3237 Bayview Avenue – Zoning By-law Amendment Application – Request for Direction Report

Date:	October 26, 2015
To:	North York Community Council
From:	Director, Community Planning, North York District
Wards:	Ward 24 – Willowdale
Reference Number:	15 112180 NNY 24 OZ

Attachment 1: Site Plan

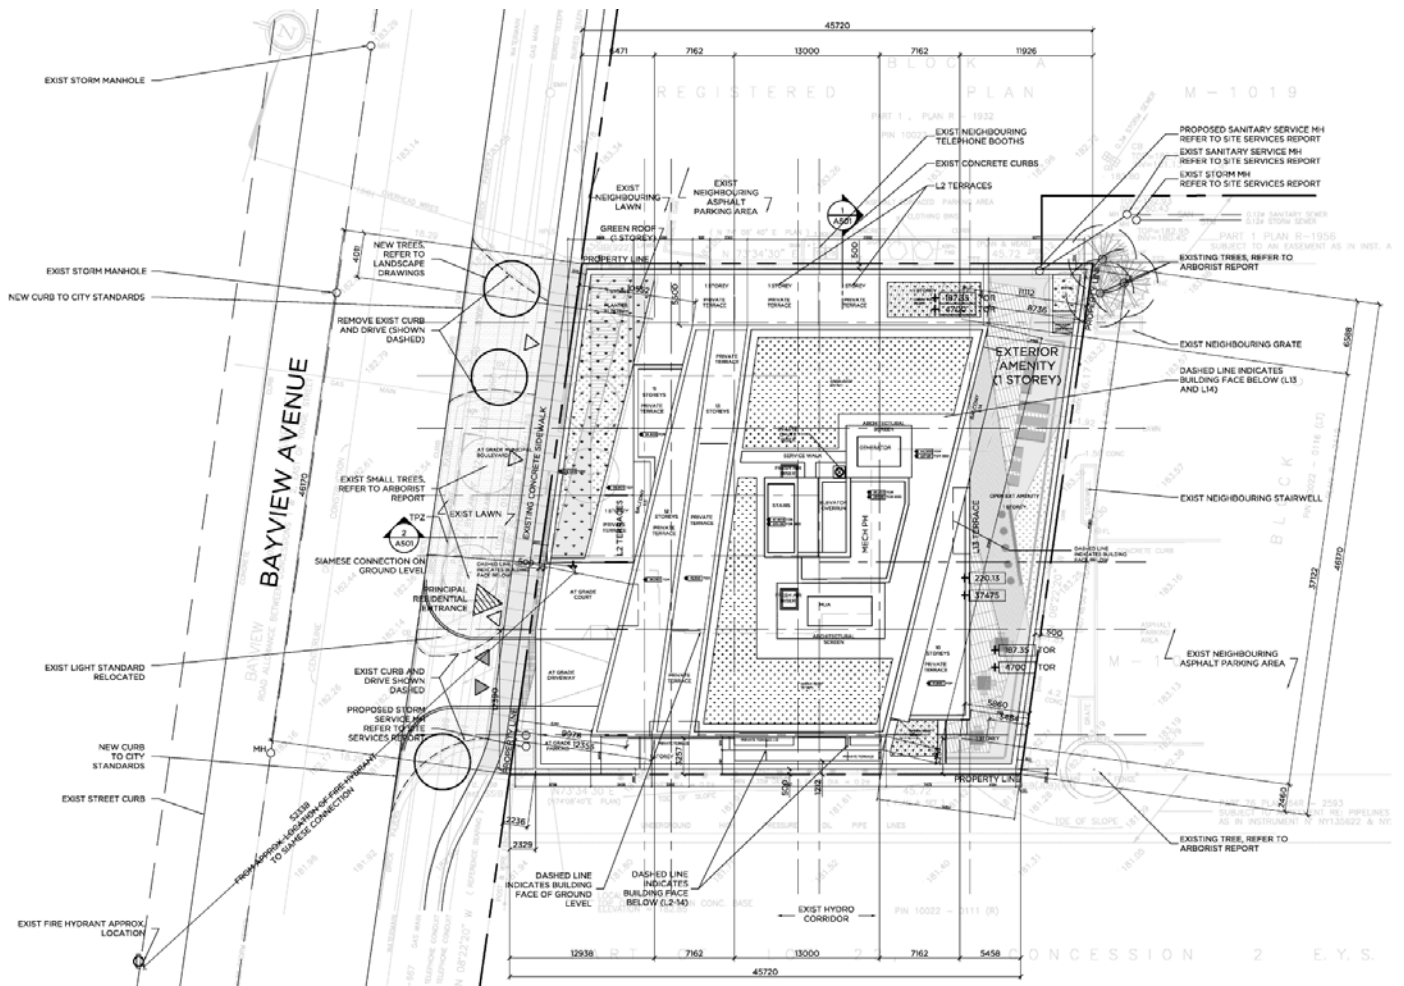
The proposed building illustrates setbacks of 0.5 metres from Bayview Avenue and the north, east and south property lines. This would result in a poor streetscape with limited landscaping and a building setback out of character with the surrounding area as required by the Built Form policies of the Official Plan. A minimum setback of 5 metres should be provided from Bayview Avenue in order to provide an opportunity for landscaping and amenity such as patio space for the proposed retail units. This setback will complement other landscape setbacks of buildings on Bayview Avenue, allowing the development to fit within the existing character of Bayview Avenue.

The Official Plan requires development on lands adjacent to *Utility Corridors* to secure the property edge through measures "such as setbacks, fencing, site grading, berms, landscaping, building treatment and construction techniques". Fourteen parking spaces are currently proposed along the south property line within the building. These spaces should be relocated below grade and the space utilized for uses which animate the utility corridor. The tower is setback approximately 3.2 metres from the utility corridor. A minimum 5 metre setback from the utility corridor should be provided to accommodate amenity areas for grade related units, walkways, lighting and landscaping to support and animate the recreational space within the utility corridor. The service area and underground parking access also utilize a significant portion of the ground floor area. These areas should be redesigned or relocated in order to mitigate negative impacts, such as visual and odour impacts, on Bayview Avenue, the lands to the east and the utility corridor.

A greater rear yard setback is recommended to accommodate minimum separation distances to future infill development on the rear property of 50 Ruddington Drive. A setback of 0.5 metres is insufficient to allow for proper separation distances between the proposal and any future development on the abutting site. A rear setback of 7.5 metres to the tower would be appropriate and a greater setback at grade should be provided to allow for landscaping.

The proposed building setbacks are inappropriate, and should be increased to allow for sufficient landscaping and planting, better reflect the character of the neighbourhood and to create a more appropriate relationship to adjacent public street and lots to the north and east and the existing utility corridor to the south. Adjacent lots may redevelop in the future and appropriate separation distances should be provided to ensure that future development is able to occur.

Of the proposed 33 visitor parking spaces, 14 are proposed at grade along the south property line. These spaces should be relocated below grade to avoid negative visual

impacts on Bayview Avenue. Relocating these spaces would also allow for at-grade residential units which would animate the utility corridor.

Attachment 2: Elevations

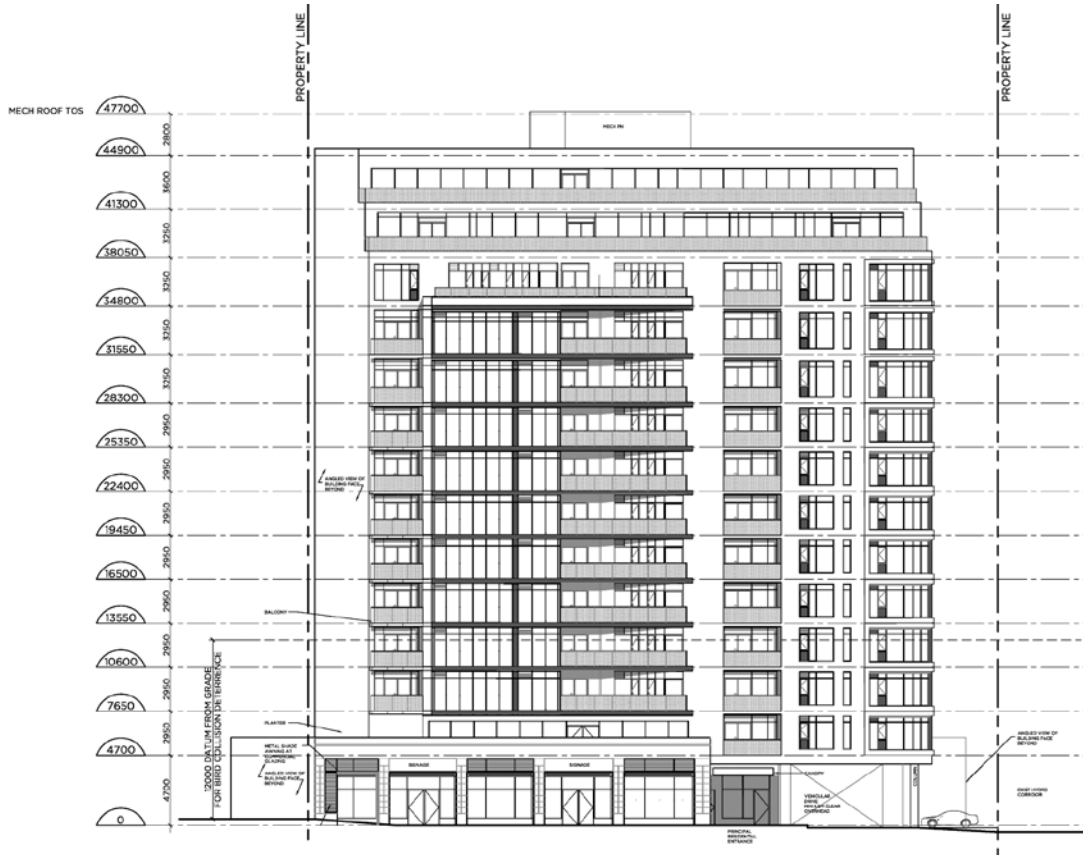
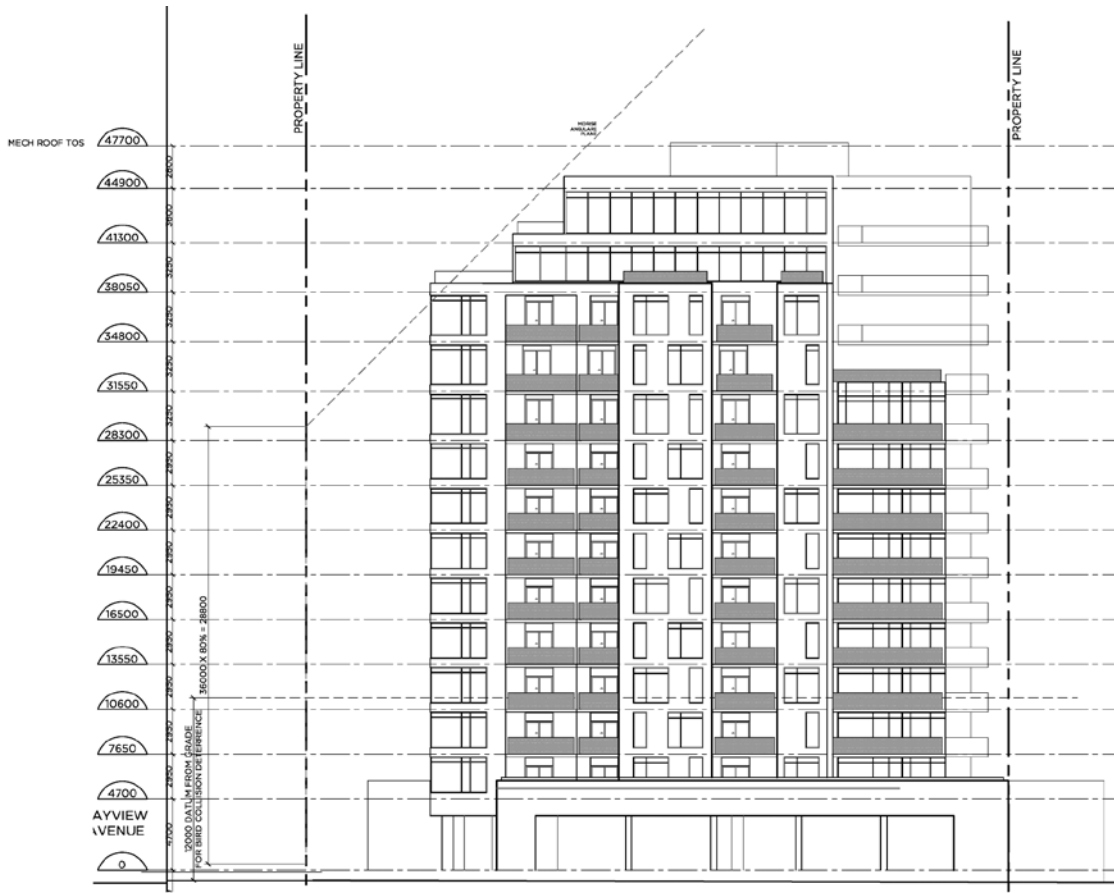
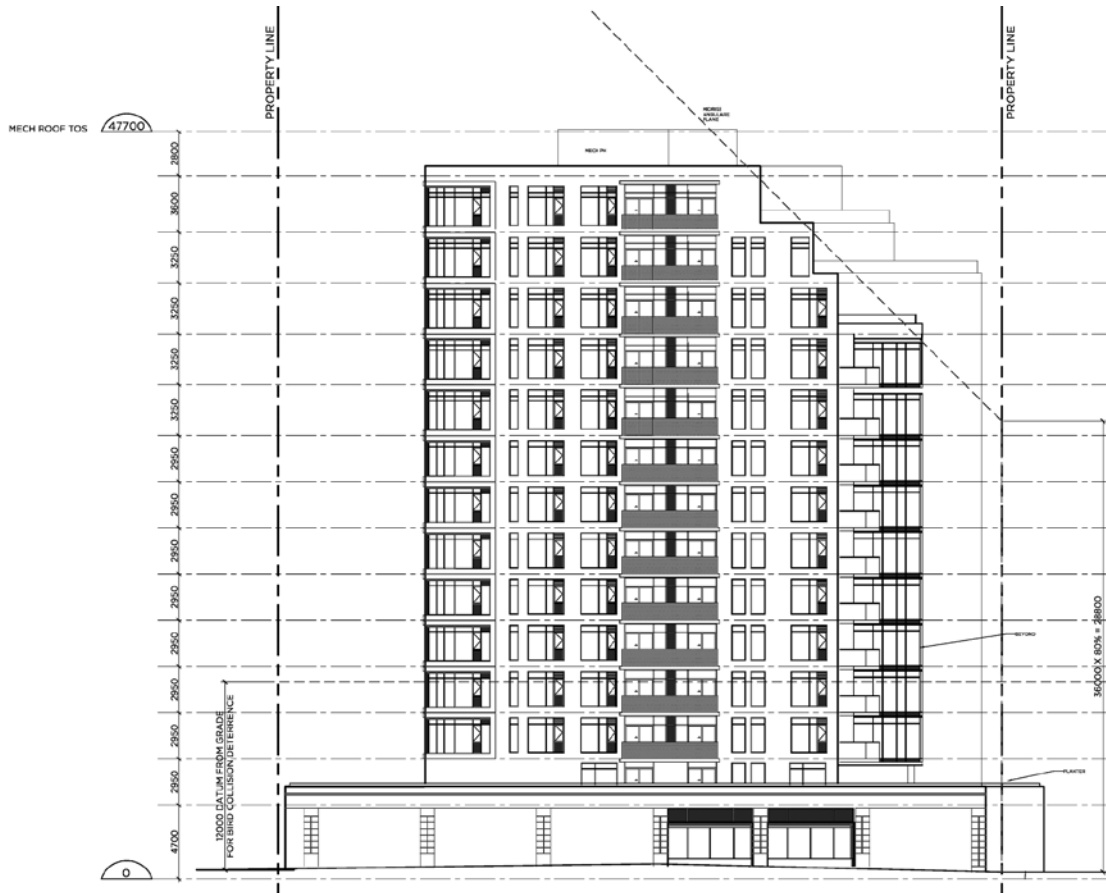
Based on the immediate context, the site is more appropriate for a mid-rise building with a maximum height of 36 metres, which provides a one-to-one relationship to the width of the Bayview Ave right of way and respects a 45 degree angular plane from the lands designated *Neighborhoods* across the street to the west. A one-to-one relationship in combination with front step backs on upper floors would allow for sunlight on the street boulevard thereby creating a comfortable, sunlit and tree lined pedestrian environment along Bayview Avenue. To respond to the low scale character of Bayview Avenue, especially the medical building across the street, a mid-rise building should have a base height of 3 storeys. While there are buildings in excess of 10 storeys in the area, they are on larger sites in *Apartment Neighbourhoods*, set within a landscaped site and are set back from Bayview Avenue and the local streets, or interior to the neighbourhood. The proposed building should be lower in height in order to respect its context and street proportion.

The applicant has submitted a shadow study as part of the application requirements. The current proposal would cast unacceptable shadows on the Bayview Avenue boulevard and residential properties within the *Neighborhoods* designation on the west side of Bayview Avenue in the morning. The height should be reduced to remove shadows on the lots designated *Neighborhoods* and to provide 5 hours of sunlight on the Bayview Avenue boulevard between 9:18 am and 2:18 pm between the spring and fall equinoxes. Shadowing would also impact the parking lot to the east in the afternoon between 2:18
